Executive Director's Recommendation

Commission Meeting: March 2, 2017

Foreign Missions Center Master Plan at the former Walter Reed Army Medical Center

Approval of comments on the draft master plan

Figure 4.22: Street Section: 14th Street, south of Dahlia Street

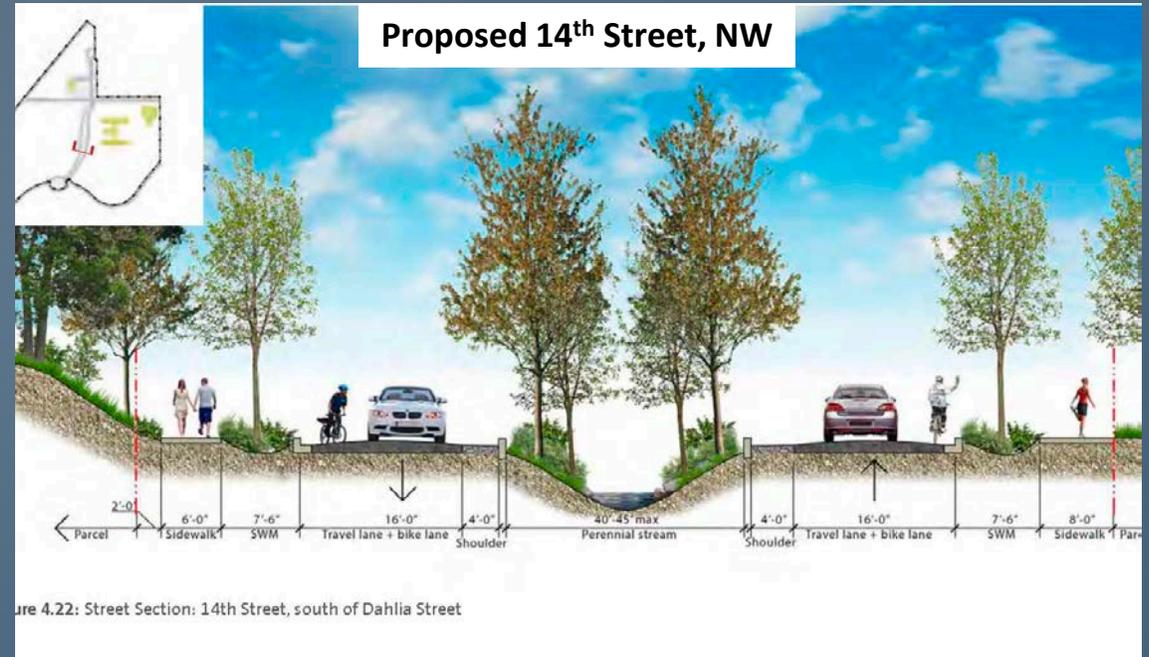
In the master plan, 14th Street is proposed to terminate to the north with a cul-de-sac. This closure is proposed at this end of 14th Street to address two issues:

- DOS needs to have the lots as large as possible to make them attractive to potential lessors and provide DOS with the greatest return to ensure a net-zero development for the campus. In order to create the greatest lot size for Lot 1 and to limit cut through traffic, DOS has included a proposal to close 14th Street, NW on its northern end.
- During community meetings and part of the NEPA process DOS states it received comments from residents living nearby the campus that maintaining 14th Street would increase the chance of through traffic from the WRAMC developments impacting their neighborhood.

DDOT weighed in on this issue in a letter dated August 11, 2016 responding to the draft Comprehensive Transportation Review and noted that "...the closure of the 14th Street and Alaska gate concentrates impacts at remaining site entrances and limits connectivity within the vicinity." In order to create a better urban experience and fully reconnect the roadway network staff **recommends that the DOS explore connecting 14th Street, NW to Alaska Avenue, NW to complete the street network in this part of the District.** In a subsequent letter dated February 14, 2017, DDOT raised issues including: the timing of mitigation for the redevelopment of the entire WRAMC site, constructing roadways to DDOT standards, and other transportation related concerns. Staff **requests that DOS address DDOT comments on the Comprehensive Transportation Review.**

- **Recommends** that DOS explore connecting 14th Street, NW to Alaska Avenue, NW to complete the street network in this part of the District.
- **Requests** that DOS address DDOT comments on the Comprehensive Transportation Review.
- **Supports** the DOS recommendation of no on-street parking at the FMC due to security concerns.
- **Recommends** that the Commission support the 1:1 proposed parking ratio, but also requests that DOS encourage the foreign missions that develop at the FMC to improve the parking ratio, where possible.

Figure 5.30: Foreign Missions Center - Chapel Zone Lot Diagrams

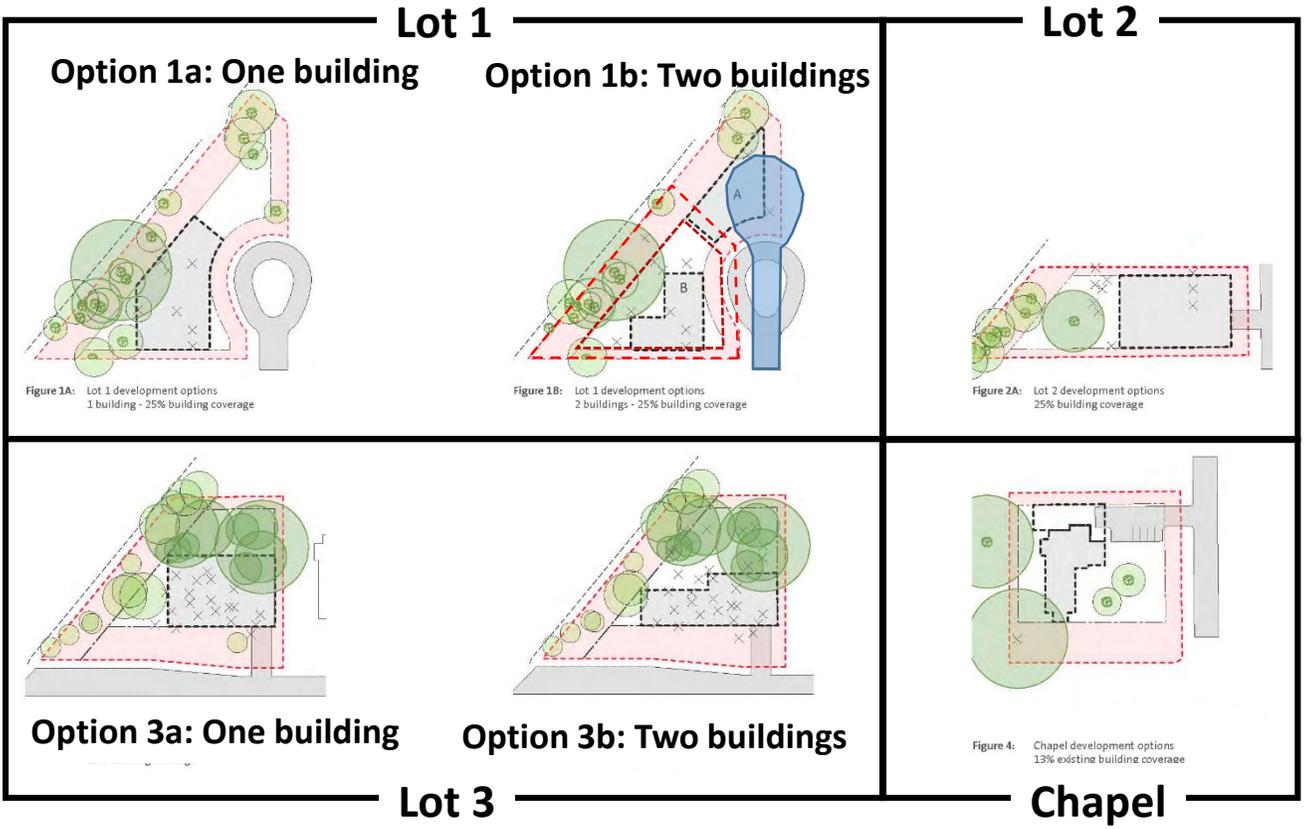
- The diagrams included in the draft FMC Master Plan show potential lot development for all the proposed streets and include setbacks, building location and street façade. Currently, these diagrams show different building locations along the length of each street. The building line, which is the distance from the building façade to the street, along both 14th and Dahlia Streets, NW should be the same to create a more consistent, cohesive look for the campus. Staff therefore **encourages DOS to create a consistent building frontage along both the northern portion of 14th Street, NW and Dahlia Street, NW.**

- **Encourages** DOS to create a consistent building frontage along both the northern portion of 14th Street, NW and Dahlia Street, NW.
- **Encourage** DOS to maintain as much of the existing remnant forest area as possible as these individual sites are developed.

Lots 8, 9, 10

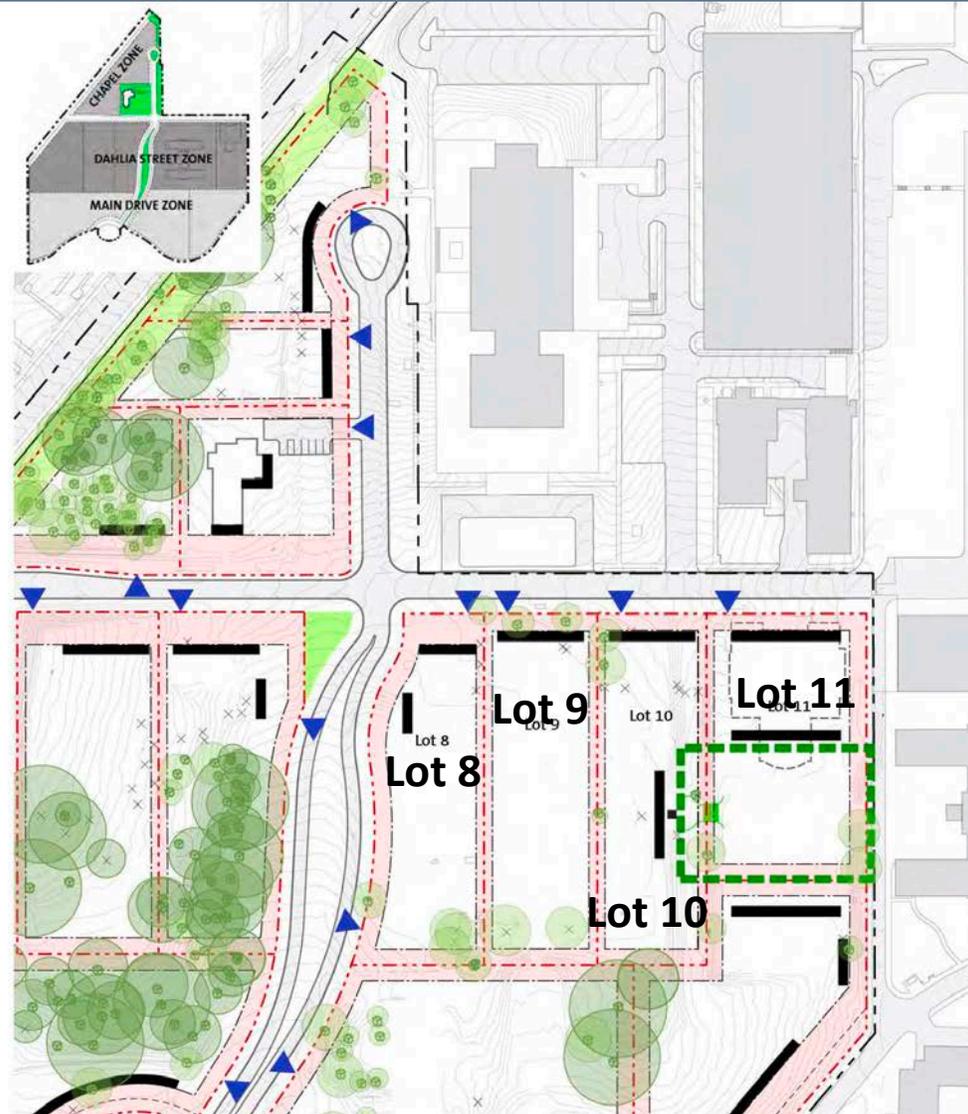
- Staff discussed the need to maintain the axial relationship between Building 40 and Building 1 earlier in this report. The diagrams depicting Lots 9, 10 and 11 do not include building massing that respect the special axial relationship that currently exists on the campus between these buildings. If a foreign mission chooses to demolish building 40 then any new building should seek to preserve this axial relationship as well. Staff **supports the reuse of Building 40 as it will best maintain the historic axial relationship with Building 1.**

- **Supports** the reuse of Building 40 as it will best maintain the historic axial relationship with Building 1.
- **Requests** that DOS add additional detail in the guidelines for Lot 12 to engage Main Drive more appropriately as this property will serve as the main entrance of the FMC campus from 16th Street, NW.

Figure 5.36: Foreign Missions Center - Main Drive (west) Zone Lot Diagrams

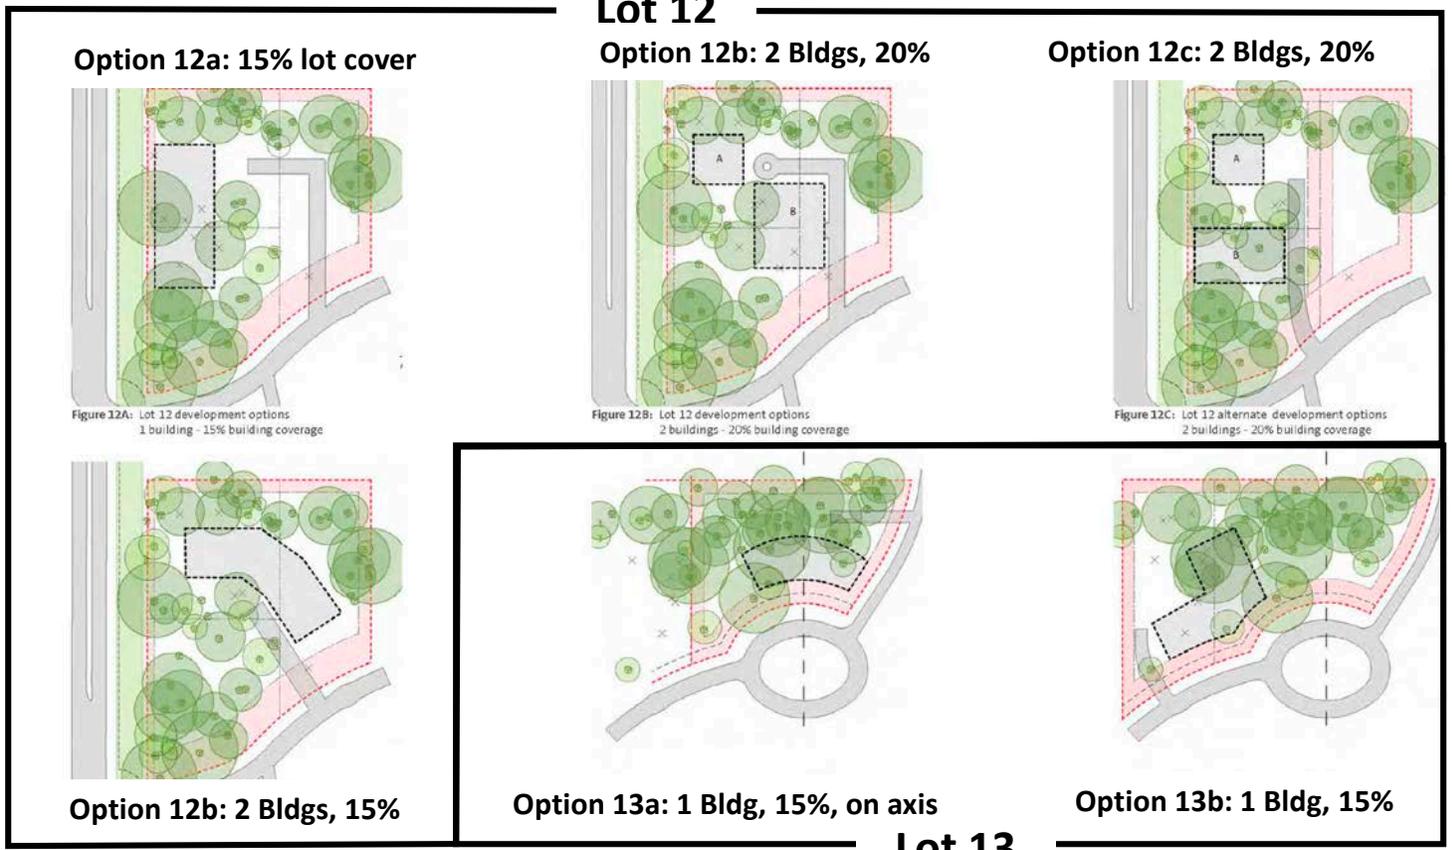
- Staff recognizes that Lot 12, the westernmost lot proposed along on Main Drive, will be next to the main entrance into the FMC. Given that Main Drive will be the main entrance into the FMC, staff believes that some care should be given to how this building is oriented on the lot as it will be prominently displayed on the campus. Staff **requests that DOS add additional detail in the guidelines for Lot 12 to engage Main Drive more appropriately as this property will serve as the main entrance of the FMC campus from 16th Street, NW.**

Lot 14

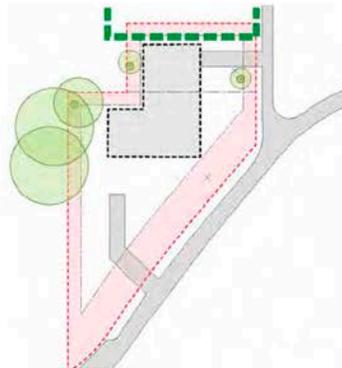
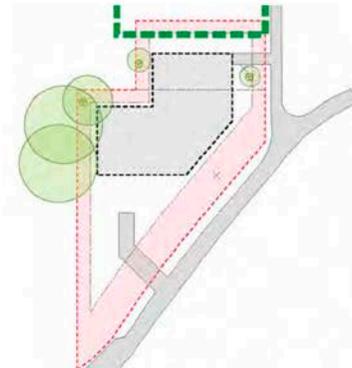
- Staff is not clear why Lot 14 is so large and believes that additional guidance should be provided regarding the siting, massing and height of any new development on this lot. DOS could also subdivide this proposed lot into two lots similar in size to other proposed lots on the campus. Staff **encourages DOS to either establish additional guidelines for Lot 14 regarding building siting as it is the largest lot at the FMC or consider separating it into two lots which would be more consistent with the size of other proposed lots at the FMC.**

- **Encourages** DOS to either establish additional guidelines for Lot 14 regarding building siting as it is the largest lot at the FMC or consider separating it into two lots which would be more consistent with the size of other proposed lots at the FMC.
